Concept Plan for the Renovation of Long Branch-Wayne Local Park

PUBLIC OUTREACH

Long Branch-Wayne LP Renovation Project

Community Meeting #1 – March 8, 2016

Concept 4

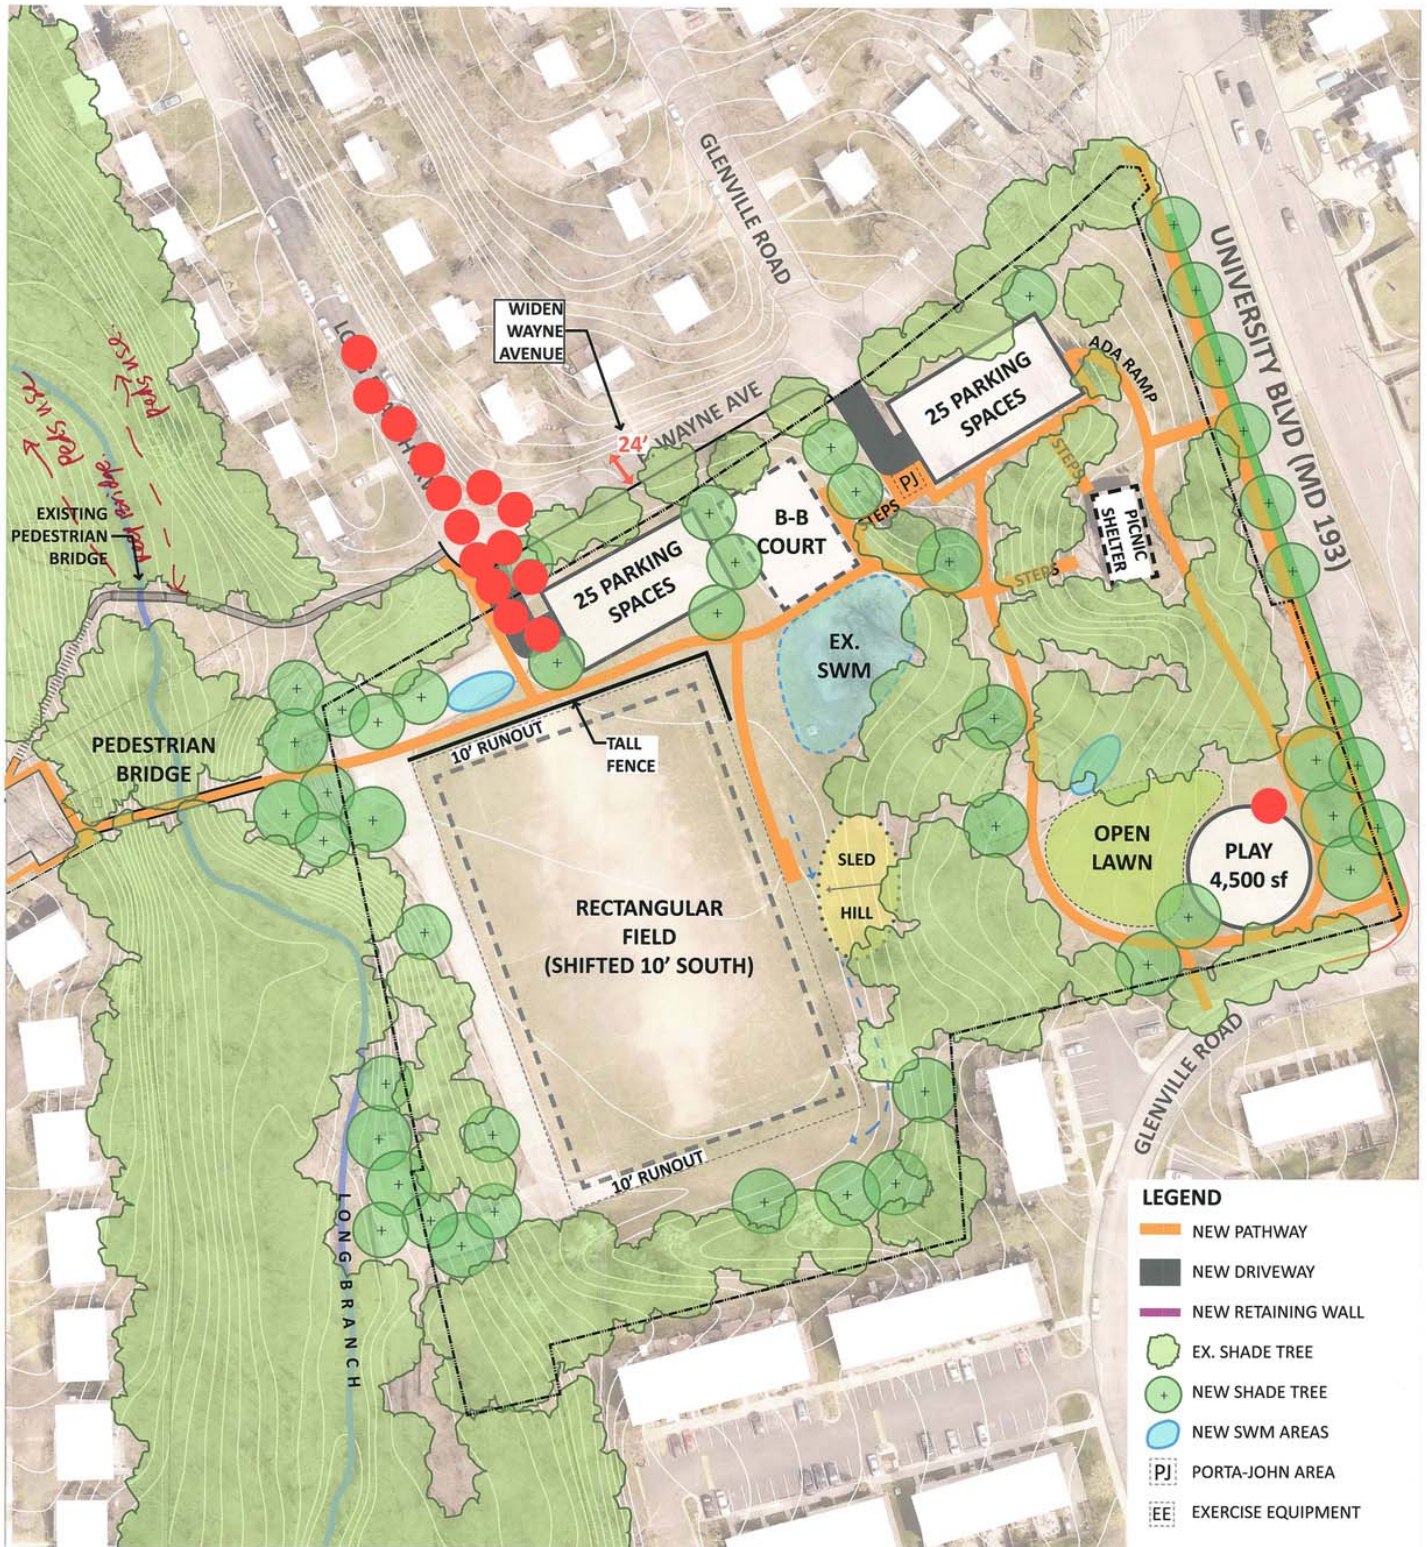
1. **Concept 4** – Concept 4 was identified as the most preferred plan during the meeting, since it received the highest number of green dots (22) and positive reception in general. Park staff clarified that the feasibility of this concept was contingent on obtaining approval from Pickwick Village for vehicular access through their property to Glenville Road. Specific community comments on Concept 4 included the following:

Community Meeting 2:
Red/Green Dot Exercise Results

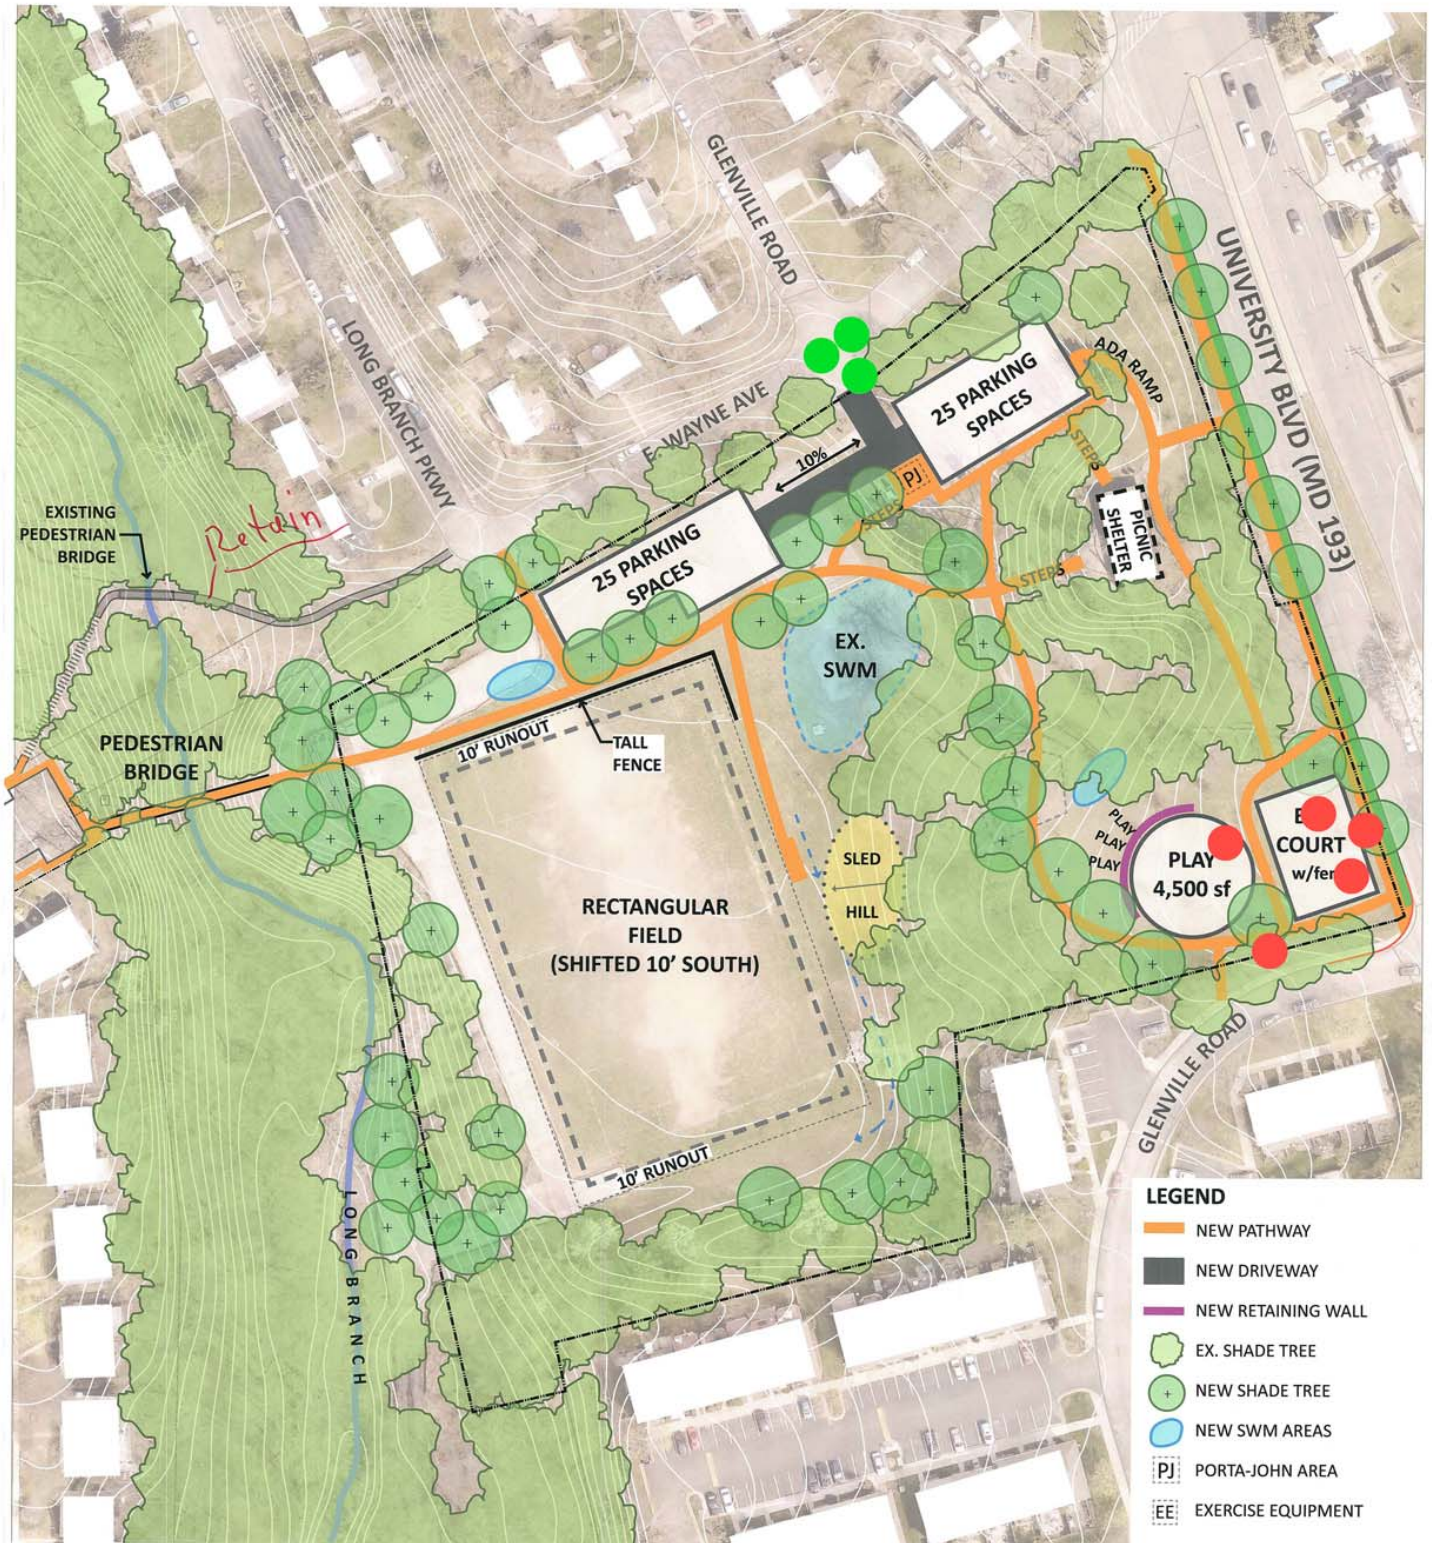
Play areas too distant from community parking

Community Meeting 2:
Red/Green Dot Exercise Results

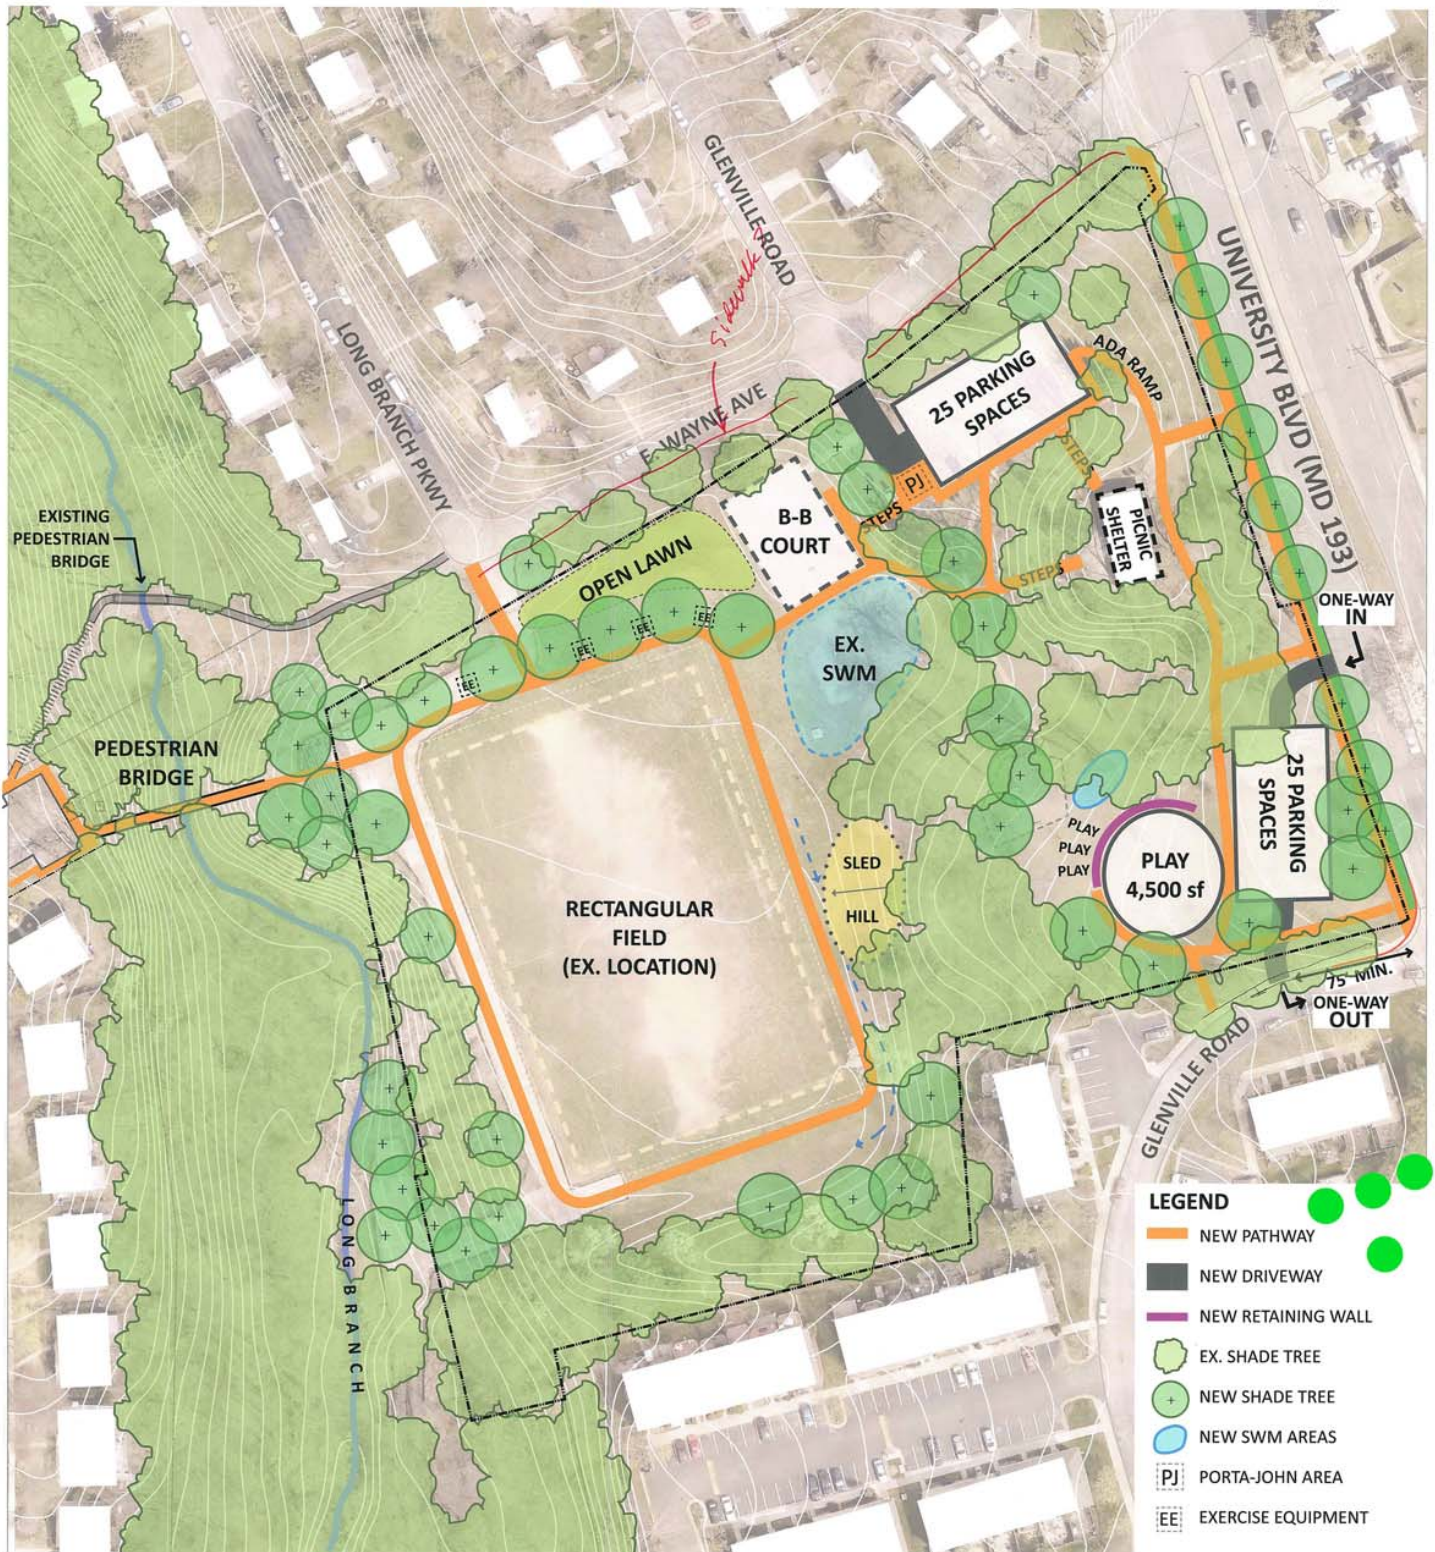
*Prefer this: one over the other.
Field should be des. planted as a soccer field, but accounting should be done to maintain the quality of the grass (e.g., irrigation, grass type, crown, etc.)
Could the loop be opened through here?*

Community Meeting 2:
Red/Green Dot Exercise Results

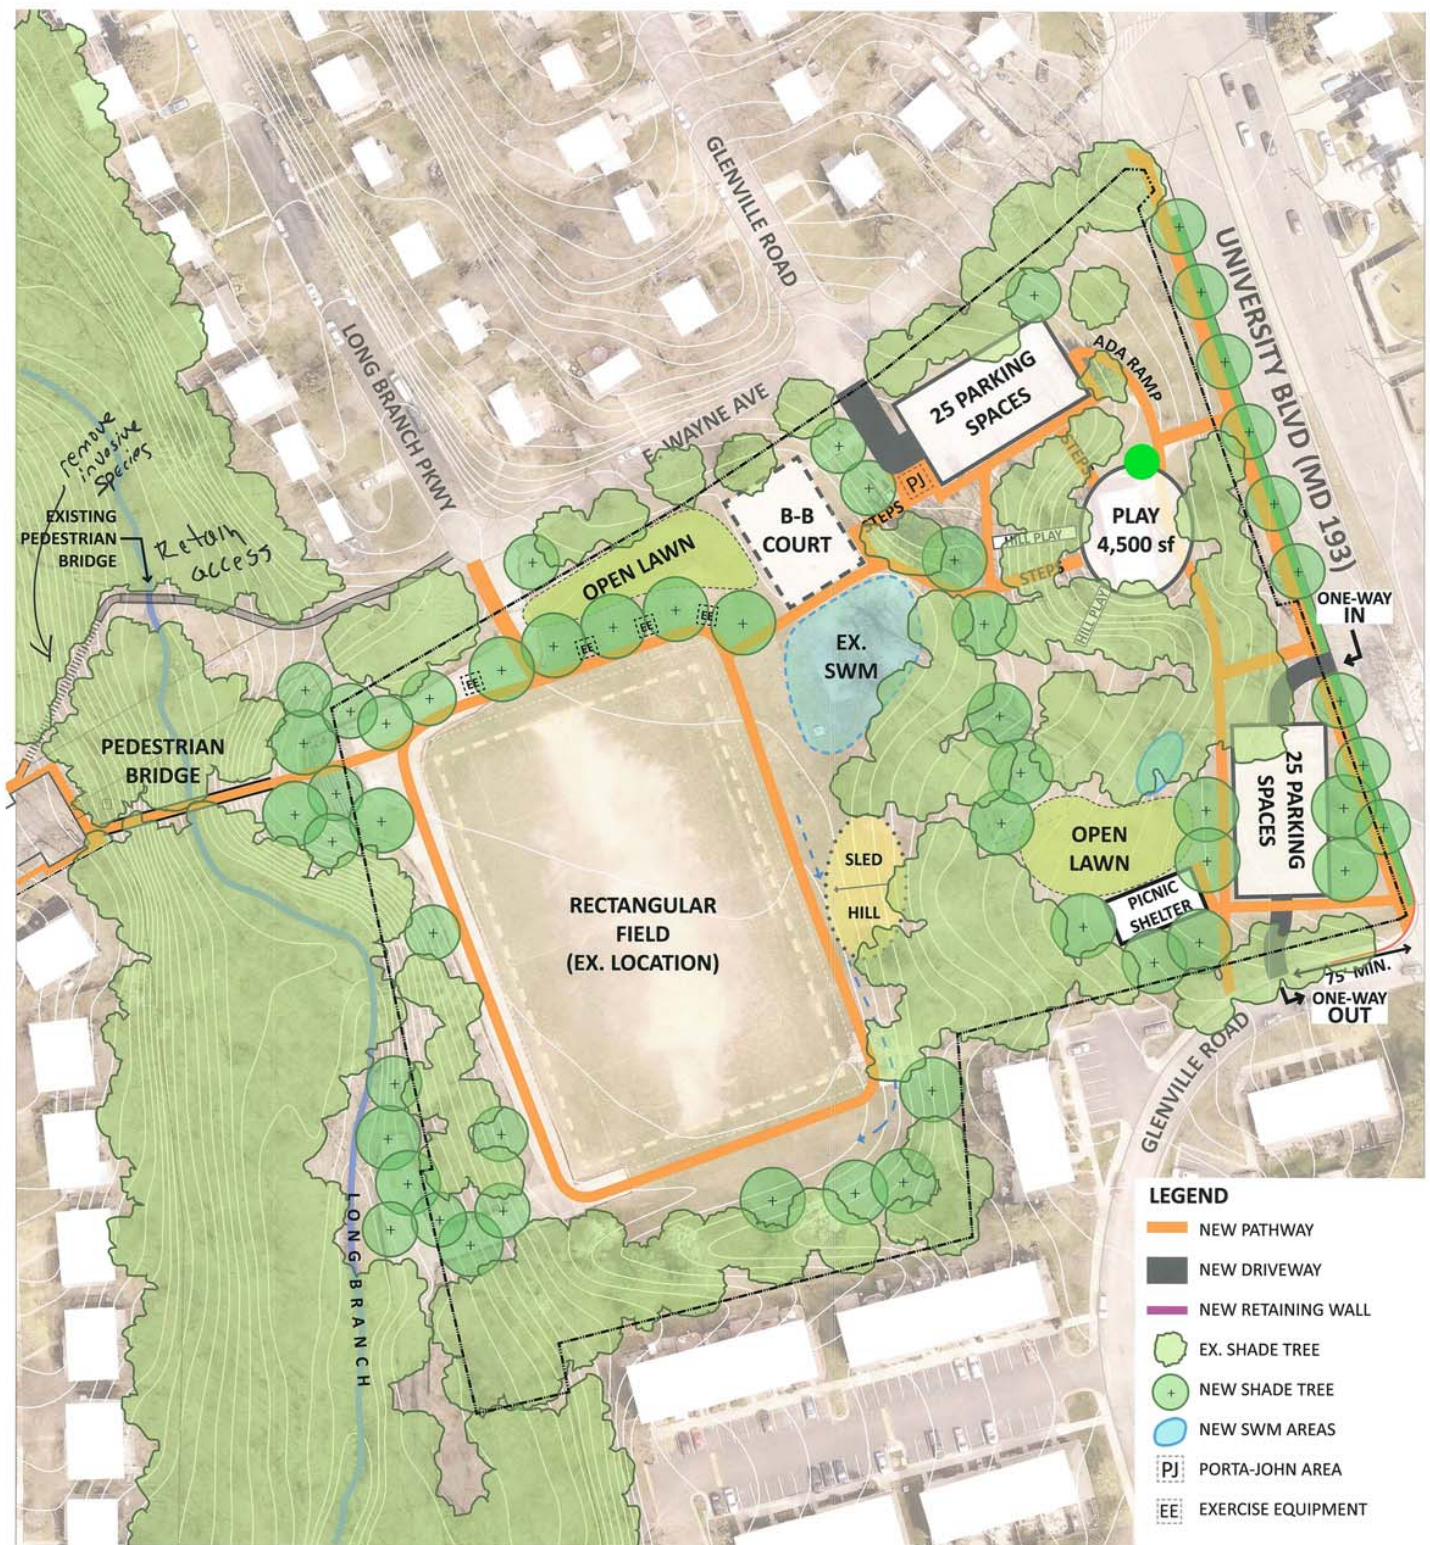
Like playground location
like picnic shelter location
like trail wound - agree

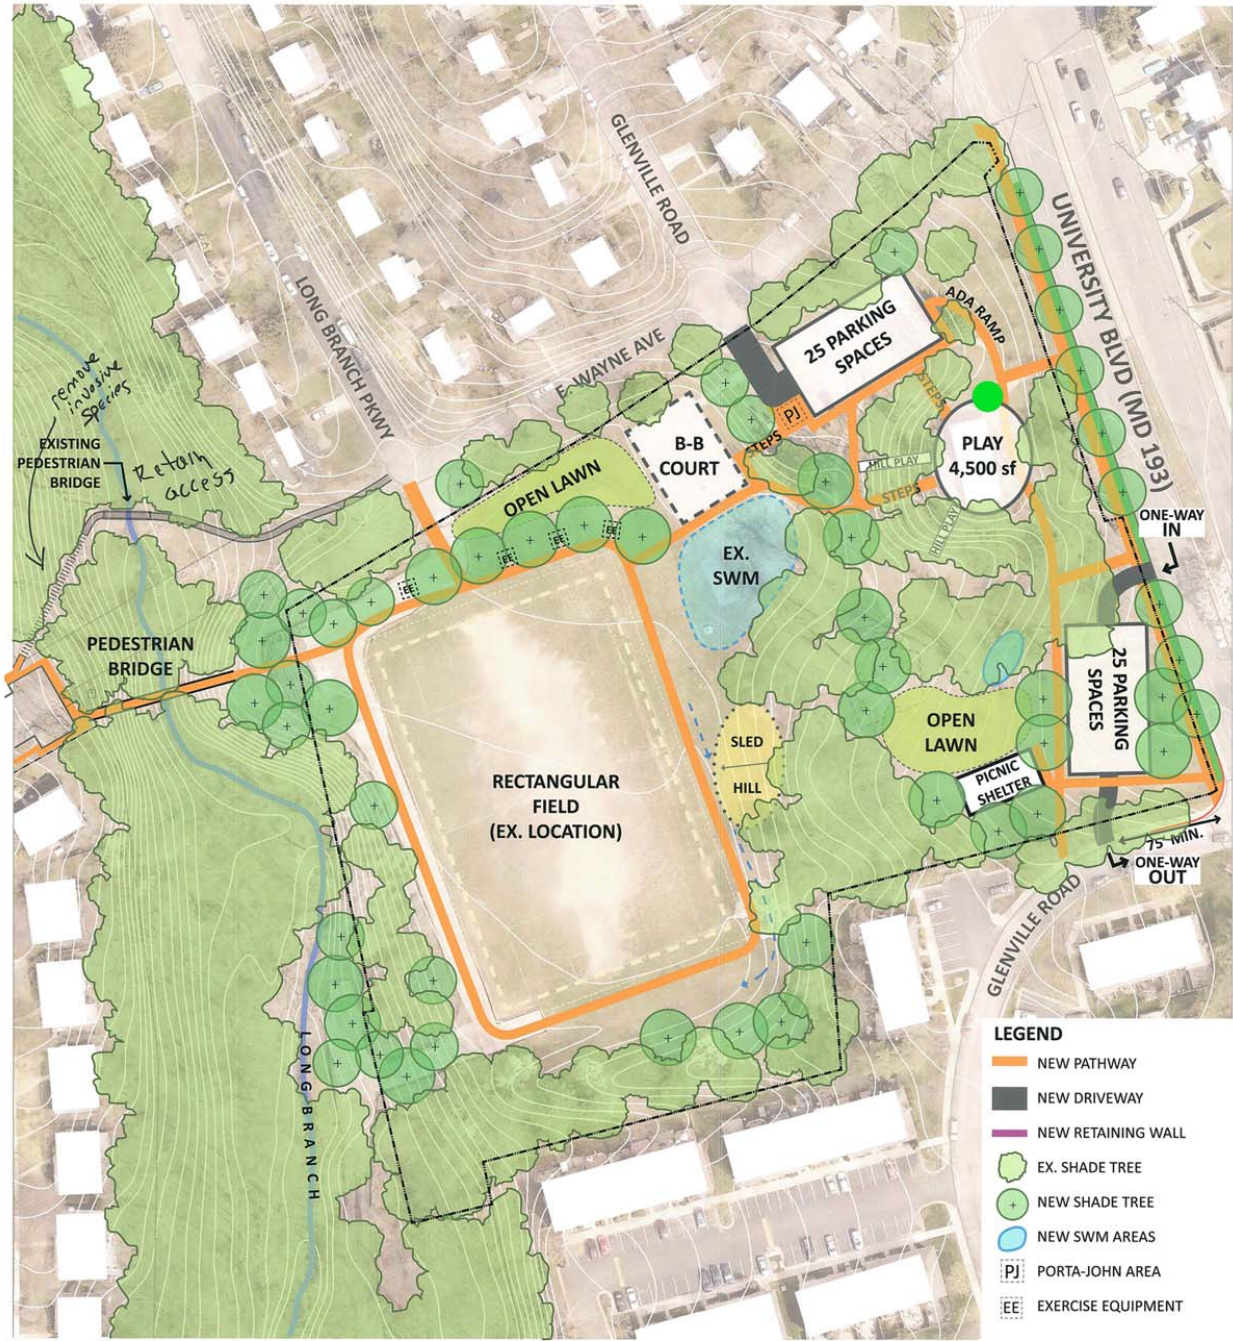
Like playground location *add!*
 like picnic shelter location
 like trail wound - agree
